To: Tim Moore, Public Works Manager
From: Laura C. Lamberty
CC:
Date: January 23, 2006
Re: 2125 N 13th – TEDS Exception Request

SUBJECT: Request for Variance for Parking Space Requirements,
Parcel Number 29-45-122-00-75.

Re: Design Exception #DE05-06 – 2125 N. 13th St. – Parking Lot Layout Requirements

RE: 2125 N 13th St. -- Parking lot layout requirements

FOUR-PLEX PROJECT
Terry Anderson
Parcel # 29-45-122-00-75
2125 North 13th Street
Grand Junction, Colorado

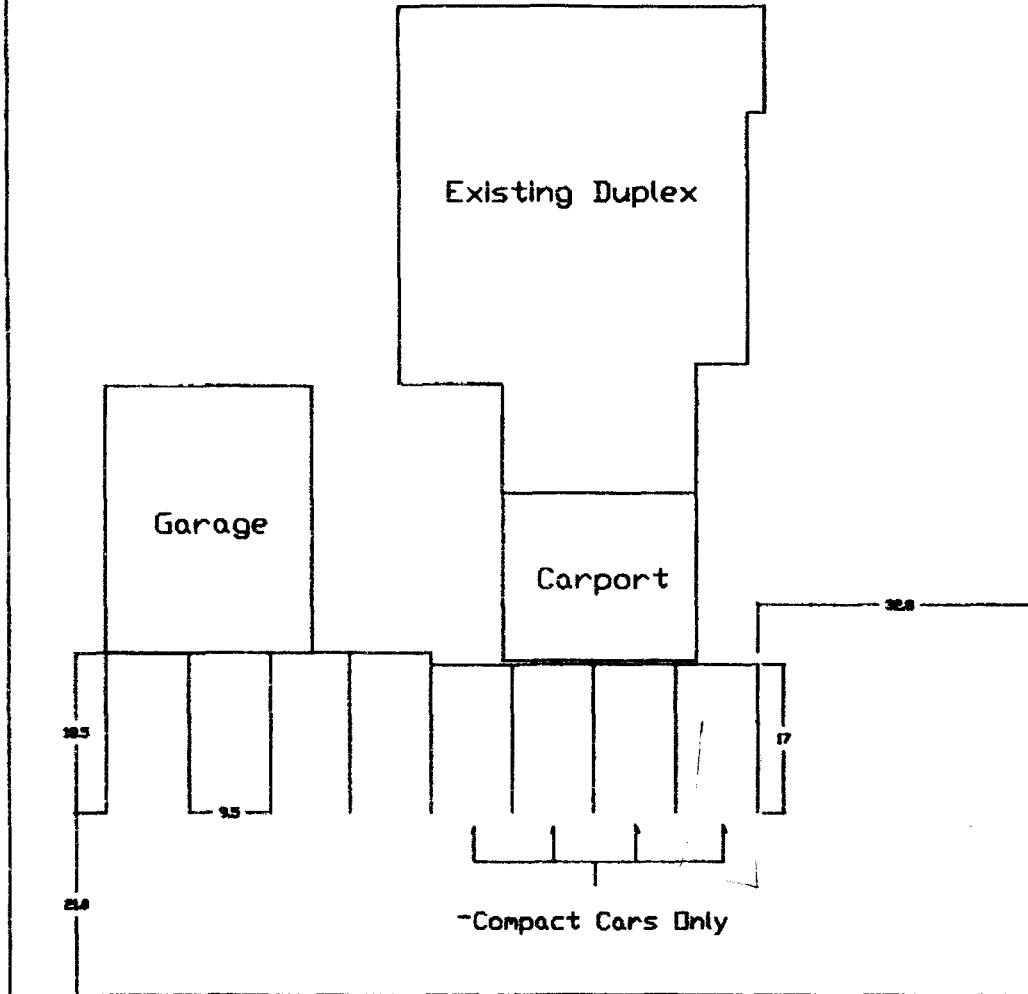
TEDS 4.3.2.1 Stall length 18 .5' (requested to vary to 17' for compact cars on 4 of 8 spaces)

TEDS 4.3.2.1 Aisle width for 9.5' wide/90 degree parking: 21' (vary from 24')

Analysis: Our parking standards are not necessarily part of a universal standard and are somewhat conservative. For instance, there are no allowances for "compact cars". This is not a safety issue as much as it is a matter of convenience. Aisle widths have been varied on regular basis for parking garage projects.

A layout of the proposed parking configuration is illustrated on the attached figure. Four of the parking spaces in the western portion are 18.5 feet in length and the four to the east are 17 feet in length and labeled as "Compact Cars Only". The width of the aisle is 21 feet. All parking spaces are a sufficient distance from 13th Street which is immediately east of the subject property. Photographs showing the area of the proposed parking spaces are also included in this request

Please find attached the committee's decision for the above referenced request. This design exception has been approved as requested. You may use this decision to proceed through the development review process for this exception.

Staff recommends approval of the TEDS Exception as presented.
